City of Phoenix
 PLANNING AND DEVELOPMENT DEPARTMENT

Staff Report Z-40-19-7
August 30, 2019

Request From: [C-2 SPVTABDO](#) (Intermediate Commercial, South Phoenix Village and Target Area B Design Overlay) (1.00 acre)

Proposed Use: Multifamily residential

Figure C. Proposed Site Plan

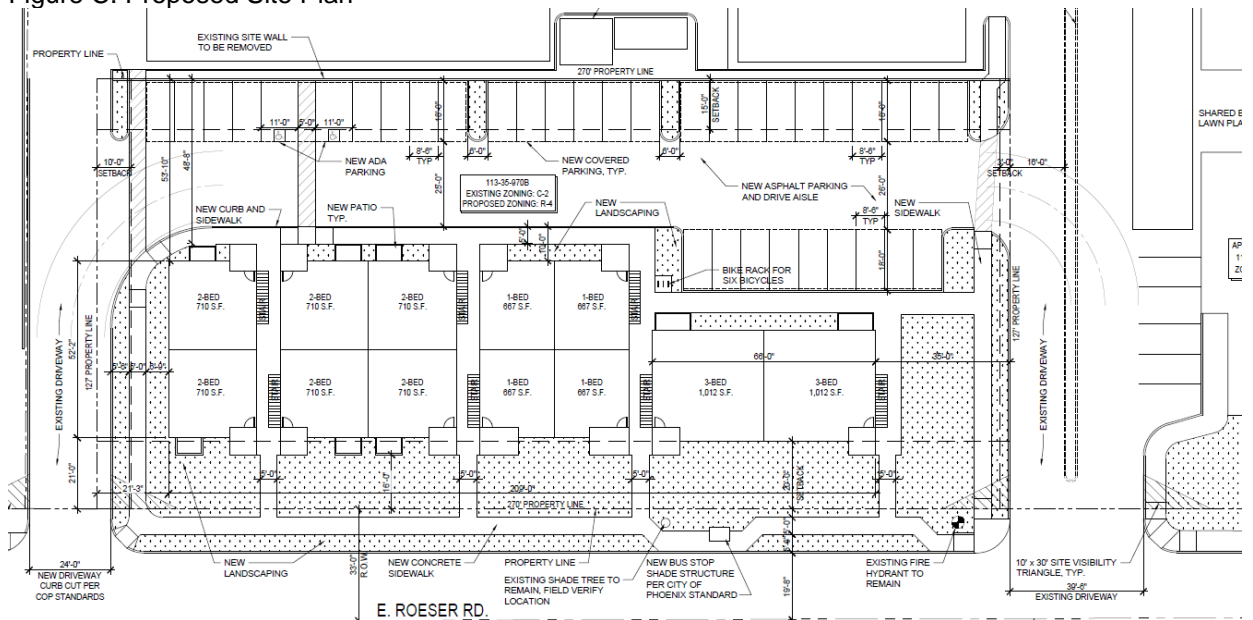
If combined with the adjacent development as planned, the site plan would be generally compliant with code; however, as a stand-alone development, the following deficiencies exist:

- A minimum five-foot landscape setback would be required along the north property line. There is no landscape setback proposed.
- A minimum 5 percent common open space is required for all multifamily projects in the City of Phoenix. There are no open spaces provided on the site, however, the larger apartment complex appears to include sufficient open space.

- A minimum of 2 resident amenities are required for all multifamily projects in the City of Phoenix. There are no resident amenities provided on the site, however, the larger apartment complex includes sufficient amenities.

Additionally, the parking supply is deficient by four parking spaces. While the development is situated in close proximity to a proposed light rail station, it is currently ineligible for the 25 percent parking reduction cited in the development standards table.

4. The developer shall provide pedestrian pathways on the east and west side of the subject site extending from Roeser Road to the north property line to provide pedestrian access to neighboring multifamily developments. Pedestrian pathways shall include the following, as approved by the Planning and Development Department:

- a. Pedestrian pathways shall be detached from the vehicular areas by a minimum five-foot-wide landscaped area and shall include minimum three-inch caliper shade trees planted a minimum of 20 feet on center or equivalent groupings along both sides of the sidewalk.

7. Fifteen percent of the surface parking lot area must be landscaped exclusive of perimeter landscaping. Minimum two-inch caliper shade trees shall be required in the surface parking lot landscape planters, as approved by the Planning and Development Department.

Figure E. Proposed Elevations (Top, Roeser Road Frontage) (Bottom, North Elevation)

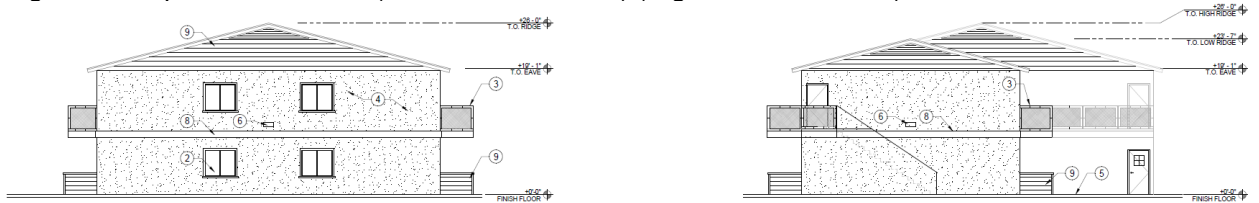
The conceptual site plan calls for a segmented two-story multifamily building. The conceptual elevations include patios, balconies, contrasting trim, and undulating rooflines which run a maximum width (east-west) distance of 62 feet. The architectural enhancements are intended to make the building more approachable and pedestrian-oriented.

1. All building facades shall contain architectural embellishments and detailing such as textural changes, pilasters, offsets, recesses, window fenestration, shadow boxes and/or overhead canopies at least every 50 linear feet, as approved by the Planning and Development Department.

5. All individual units above the ground floor shall have a shaded balcony of no less than 50 square feet in total size with a minimum depth of five feet, as approved by the Planning and Development Department.
